FINDING OF NO SIGNIFICANT IMPACT

**Revised Environmental Assessment and
"Nationwide" Programmatic *Section 4(f)* Evaluations**

**Middle Fork Flathead River - SE Essex
BR 1-2 (85) 180; Control No. 1763**

Summary of Final Coordination

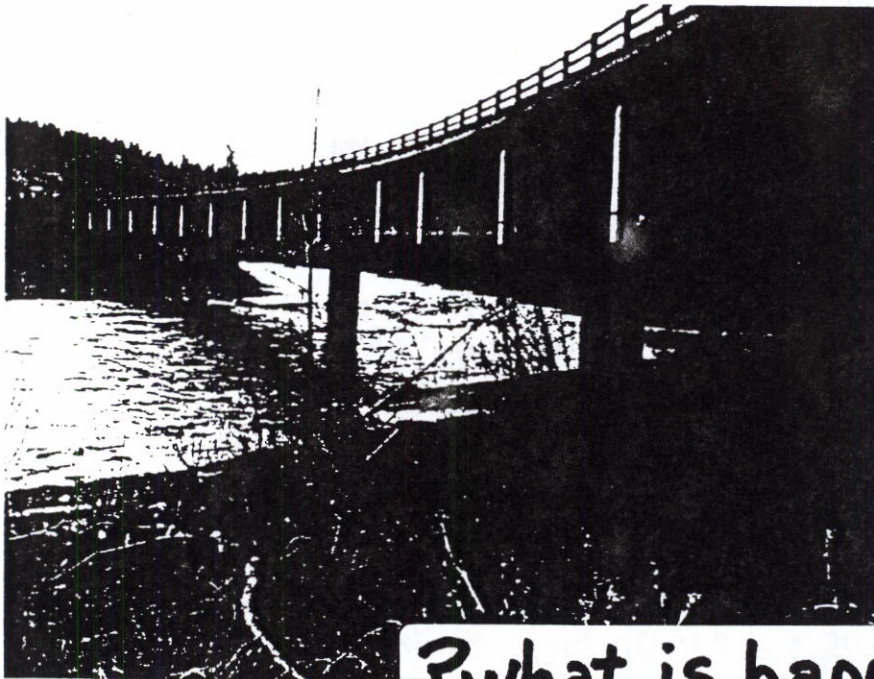
(3) What is happening to the Glacier Park beaches along the WSR river (see photo attached)? Where is a map showing the proposals and an accurate official delineation of the OHW mark (ordinary high water) that accounts for current 3 yr. drought conditions? The beaches above OHW are part of the Section 4(f) easement area. Respectfully submitted,
Encl.(3) CC: FHWA

The area shown in light purple on **Figure 2a** is the area that would be disturbed by construction of the embankment and gabion retaining wall. The location of riprap at each bridge end and the location of the gabion retaining wall are highlighted on **Figure 2c**. **Figure 2c** shows that the riprap and gabion wall at the north end (Essex end of the new bridge) would be well away from the beach referred to in the comment.

Proposed Visitor Services Zone
Walton

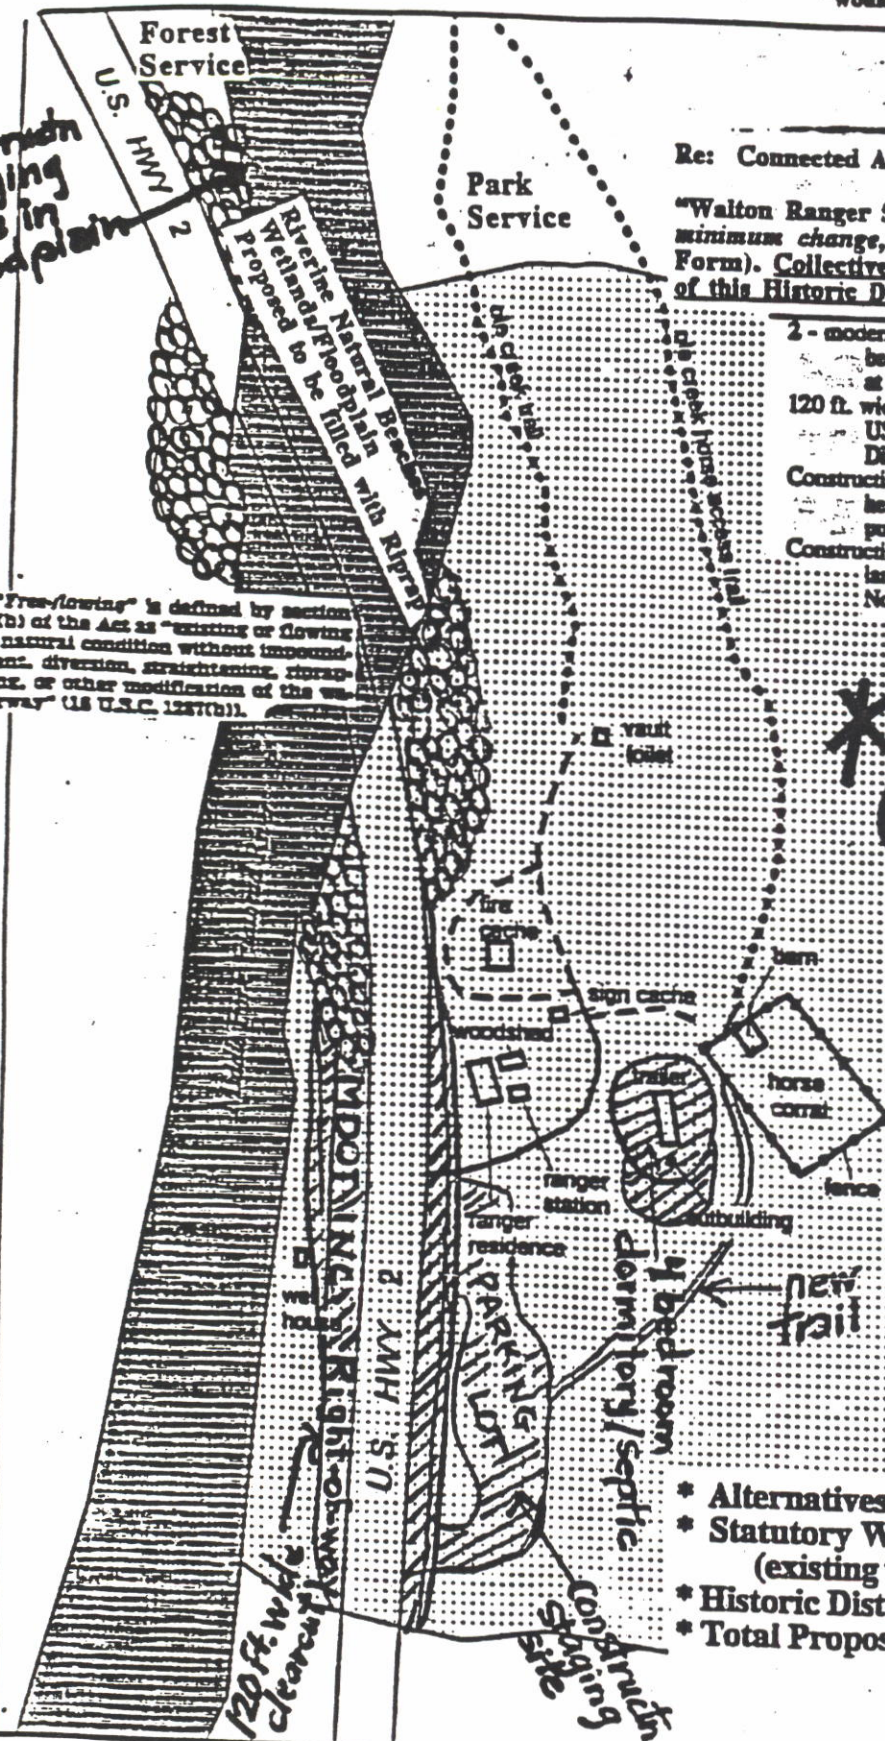
26 acre Development Zone in
"Area of High Ground Water Level" (p.16)
"Expectation of Congested Visitor Conditions" =
Visitor Services/Development Zone GMP FEIS, p. 24
EA irrationally concludes the change to Congested Visitation
"would have no known cumulative effects" !! (p.33)

Re: Connected Actions MDT CN 1763 + GLAC Walton Plan

* Contrary to MDT Revised EA, GLAC has withdrawn this proposal (3-7-01 newsrel)

- * Alternatives not considered
- * Statutory Wild & Scenic River Corridor not show (existing "near natural" setting not disclosed)
- * Historic District not shown
- * Total Proposals not shown (CCP has added)

MDT has already responded to a similar comment concerning connected actions in **APPENDIX F** of the Revised EA (see page F-17). See also MDT's response on the previous page (page FC-14).

This comment pertains to the NPS's proposed improvements to the Walton Area not MDT's proposed bridge replacement.

MDT was fully aware of the NPS decision to suspend work to implement their proposed parking and trailhead improvements at Walton Ranger Station at the time the Revised EA was published. The Revised EA conveyed this information to reviewers as can be seen in the text of the first full paragraph on page 68. The document also indicates to readers on pages 20, 68, and 79 that the proposed use of NPS land at Walton as a staging area for MDT's contractor was dropped from consideration.

The historic district was not shown on **Figure 8** (page 75) in the Revised EA that shows the Proposed Visitor Services Zone at Walton. However, **Figure 9** (page 77) shows the historic district and the same buildings depicted in **Figure 8**.

The proposed trailhead and parking improvements at Walton were not shown since efforts to develop the proposal have been suspended by the NPS and could be subject to change. The Revised EA disclosed that the NPS had released an Environmental Assessment on the proposed

**Figure 2c
Preliminary Bridge Layout**

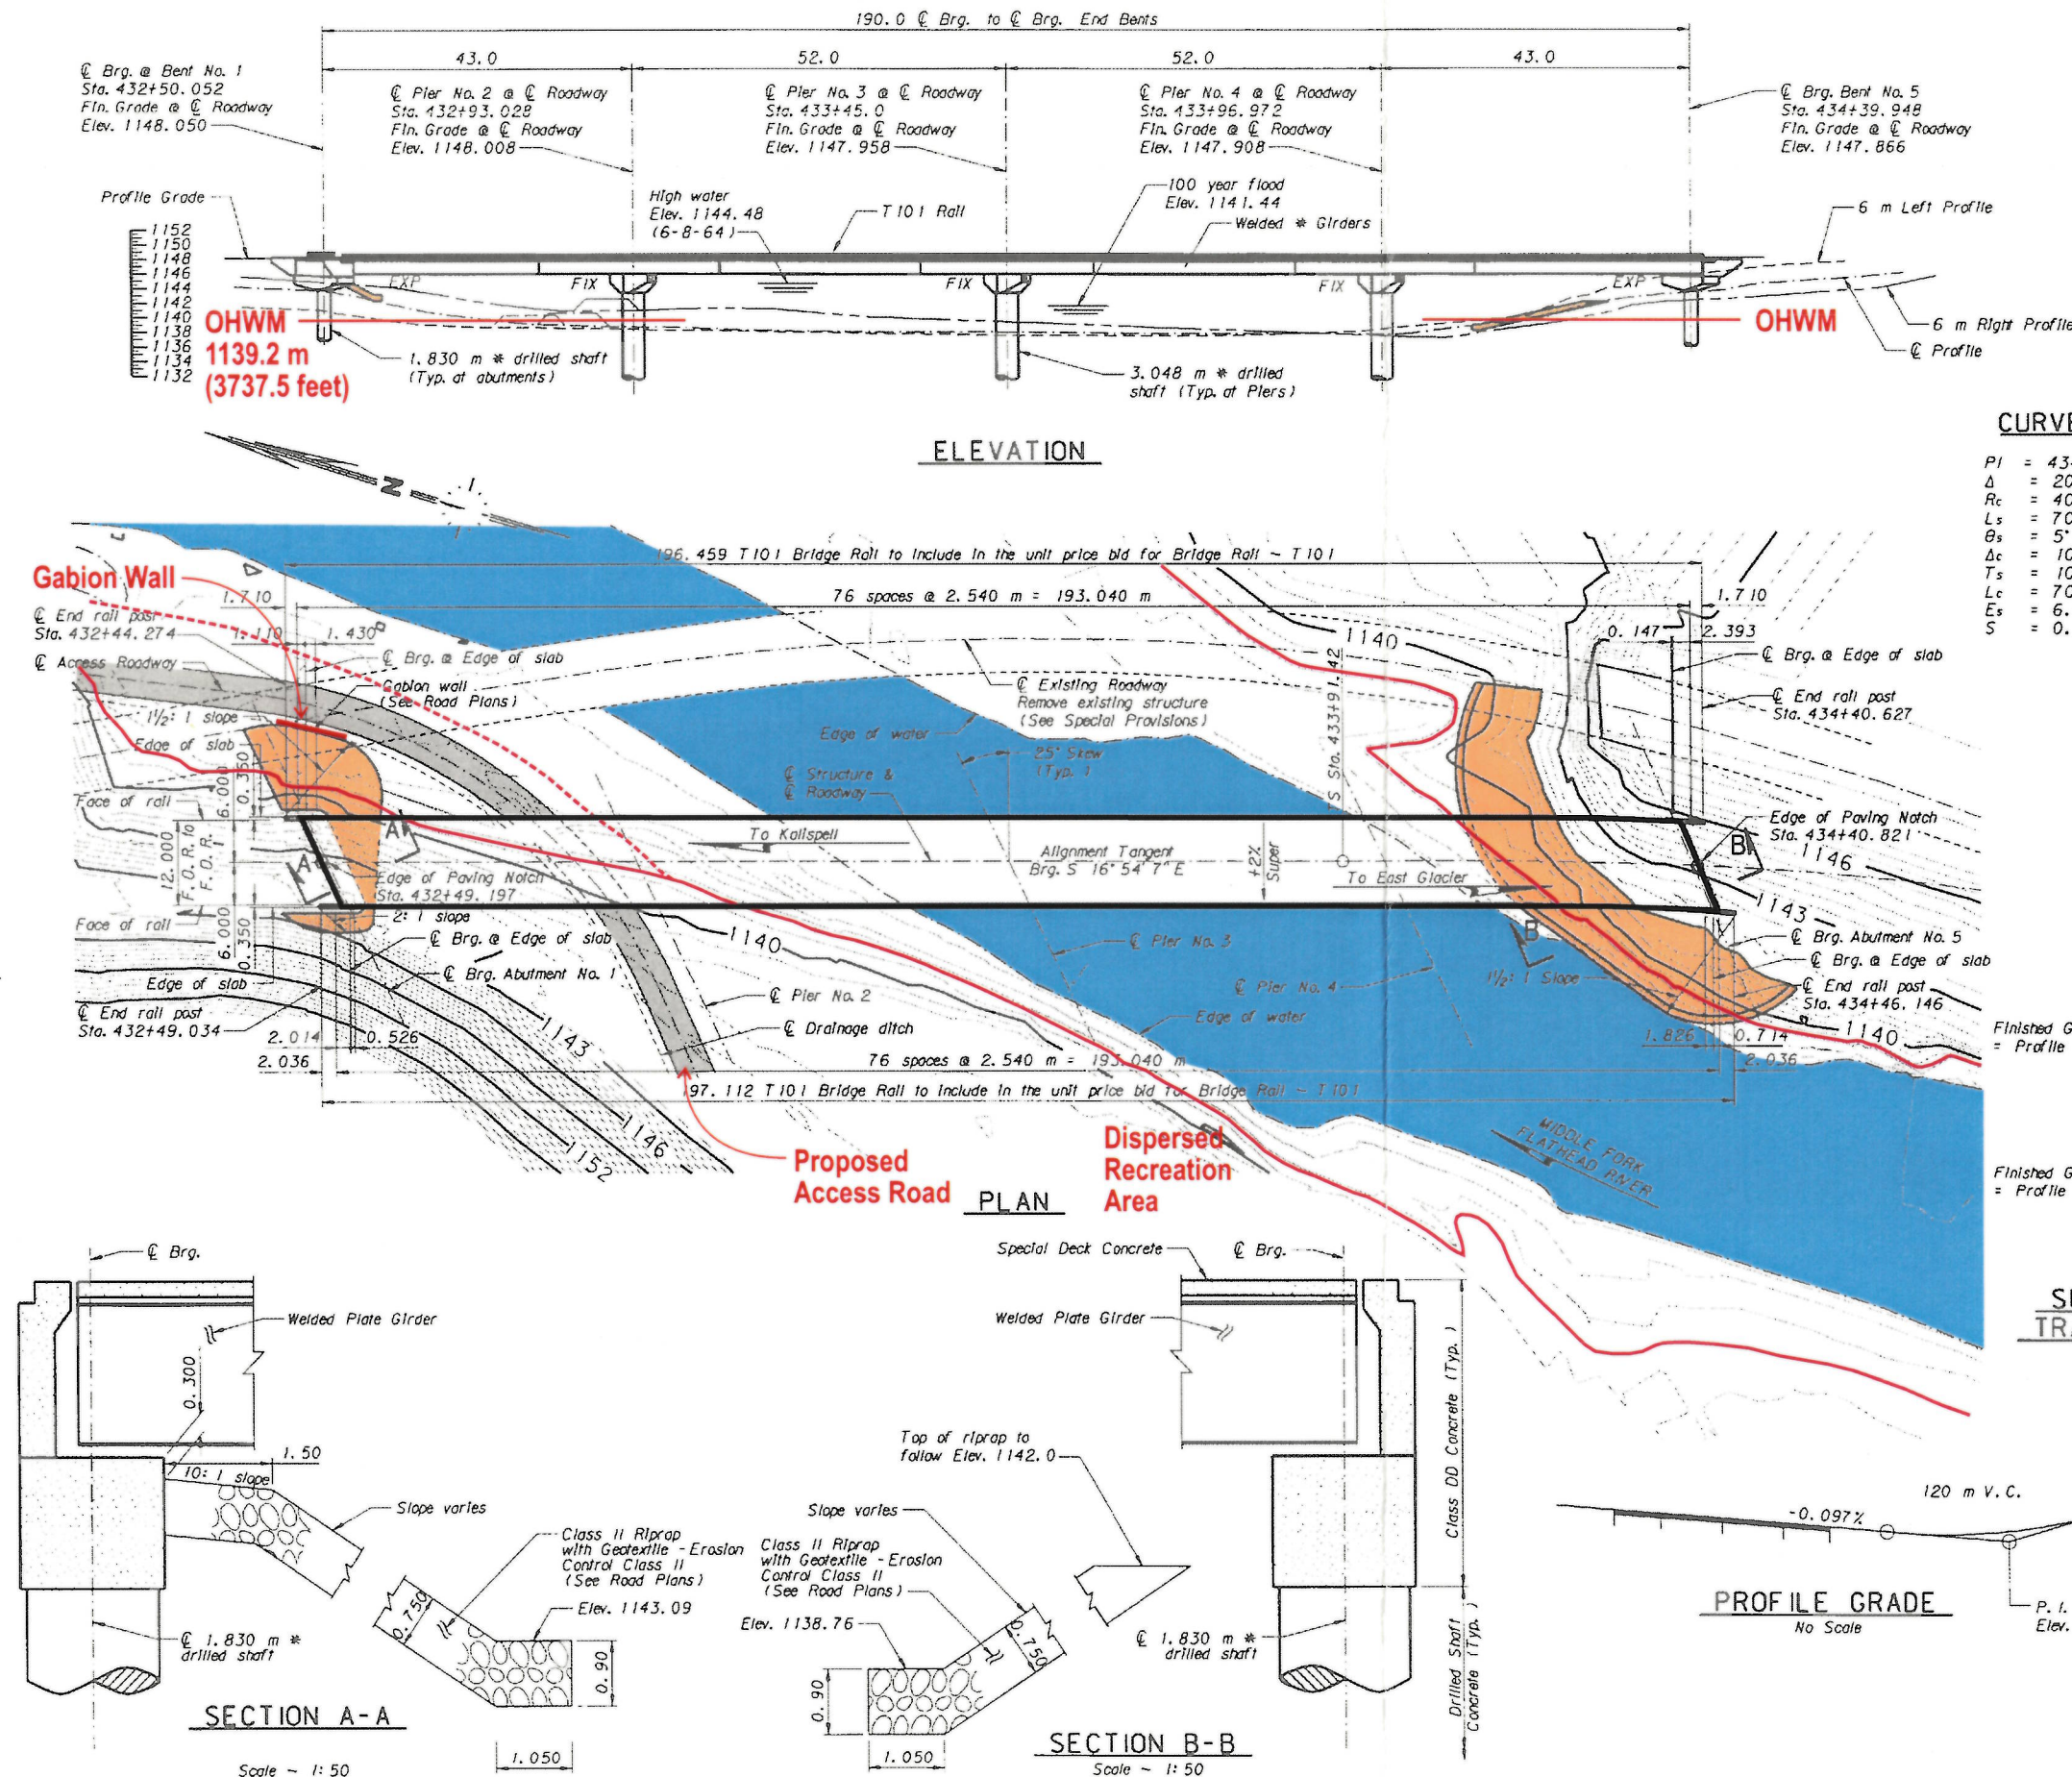
MDT has established the elevation of the ordinary high water mark at this crossing to be about 3737.5 feet (1139.2 meters). This elevation can be identified on MDT's design plans and cross-sections for this project and was used to calculate fill quantities subject to Section 404 permitting by the Corps of Engineers (COE). **Figure 2c** from the Revised EA has been modified to show the approximate location of the ordinary highwater mark. It is important to note that by constructing the proposed access road, the location of the ordinary highwater mark near the north bridge end would change due to the placement of embankment material for the road's foundation. A copy of the modified **Figure 2c** is attached.

Figure 2c included in the Revised EA (page 24) has been modified to show a more current bridge layout drawing for this project. An older version of the Preliminary Layout Plan for the proposed structure was inadvertently included in the Revised EA. Please note that the layout and configuration of the proposed riprap at each end of the proposed bridge has been modified slightly. Additionally, the approximate location of the ordinary highwater mark has been added to the **Figure 2c.**
